BEFORE THE
FLORIDA PUBLIC SERVICE COMMISSION
REBUTTAL TESTIMONY OF
ROGER L. RIGGERT
AND
JOHN DONOVAN
ON BEHALF OF
AT&T COMMUNICATIONS OF THE SOUTHERN STATES, INC. and
MCI WORLDCOM, INC.

Docket No. 990649-TP

July 31, 2000

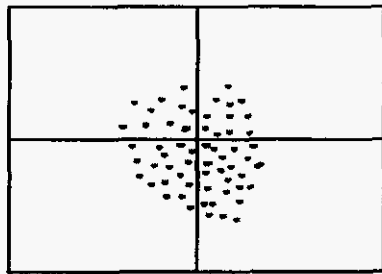
1 actual groupings of customers, demand unit boundaries may cut across
2 natural population clusters. Serving areas based on demand units may
3 therefore require separate facilities to serve customers that are in close
4 proximity, but that happen to fall in different demand units. The worst-case
5 scenario would involve a natural cluster of customers that, given distance
6 and engineering constraints, could be served as a single serving area but that
7 happened to be centered over the intersection of a set of demand unit lines,
8 as shown below.

9
10
11 This would result in the division of the natural population cluster into four
12 serving areas instead of one. As a result, a demand unit approach cannot
13 reflect the most cost-effective method of distributing customers into serving
14 areas. ICM routinely fragments natural population clusters by treating
15 demand unit lines as boundaries that distribution facilities cannot cross; as a
16 result, ICM unnecessarily duplicates facilities. Moreover, the model
17 employs two different and contradictory assumptions about uniform demand
18 distribution. In calculating the required amount of distribution cable, ICM
19 assumes that demand is uniformly distributed along roads within a demand
20 unit cell, except for demand units with 20 lines or less. In other words, the

Exhibit RLR-2

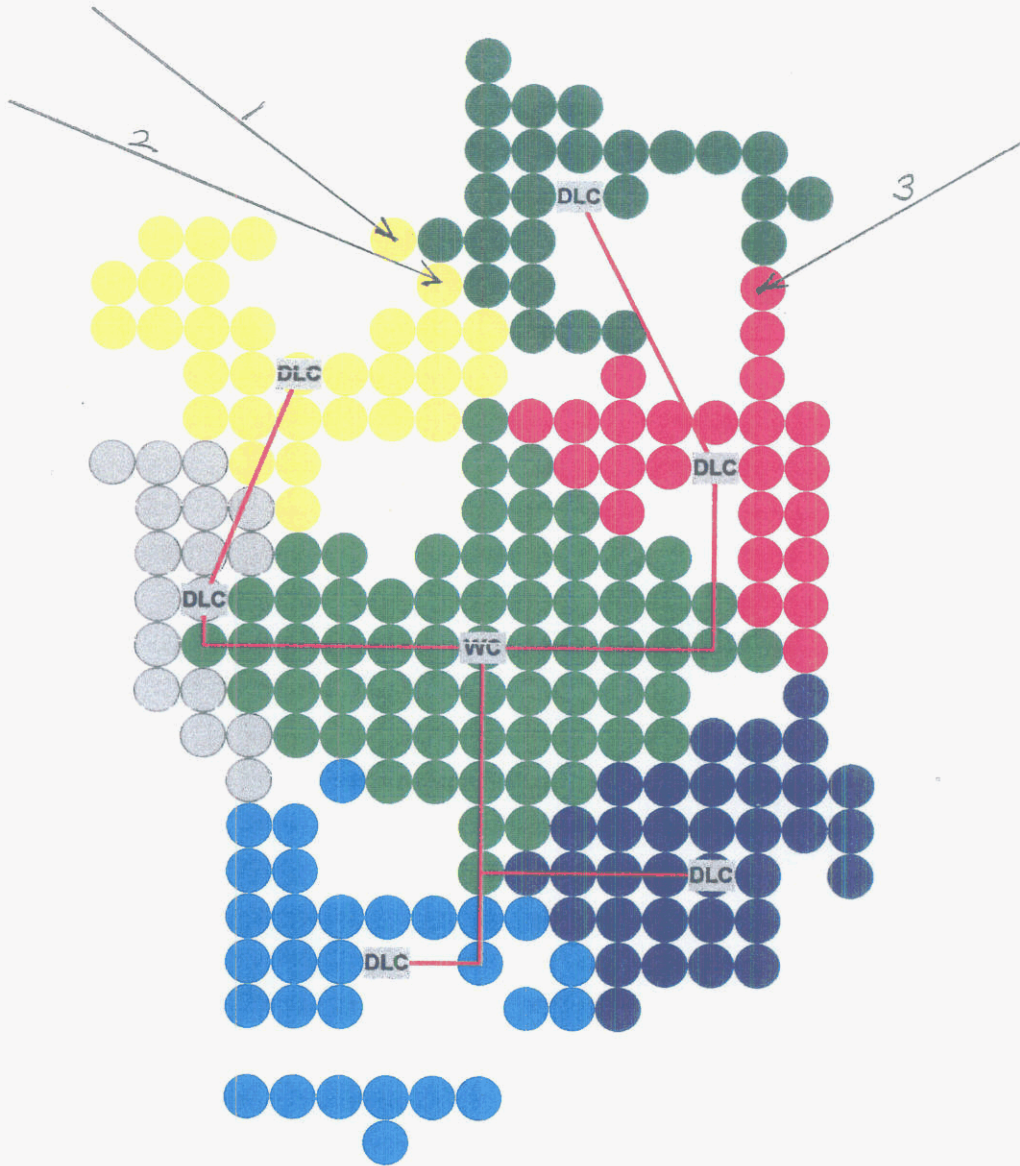
16 Further, pictures that the ICM produces of its clusters yield visual results
17 that raise questions whether the K-means clustering algorithm is operating
18 correctly. Exhibit RLR-2 contains two examples. Page one contains three
19 examples of strange clustering in the Auburndale exchange. The map,
20 produced by the ICM, contains unique colors for each cluster in the
21 exchange. This exchange has seven clusters, six of which are served by

1 DLCs. Three anomalies are designated on the clustering map. The K-
2 means clustering algorithm does not appear to be associating the
3 individual grids with the nearest cluster center in all cases. If distribution
4 plant were built to these grids based on the assignment dictated by this
5 picture, excessive plant would be placed. For example, 2 of the yellow
6 grids would be more efficiently served from the DLC in the green cluster
7 rather than having plant extend from the DLC in the yellow cluster. In
8 this particular example, the K-means algorithm can not be working
9 properly since the green grid is clearly closer to the center of the green
10 grids than it is to the center of the yellow grids. Polk City is another
11 example of an odd cluster that is developed by the K-means algorithm.
12 Situation marked 1 places a grid in the gray cluster even though all of it is
13 closer to the DLC in the blue cluster. The two examples I have shown are
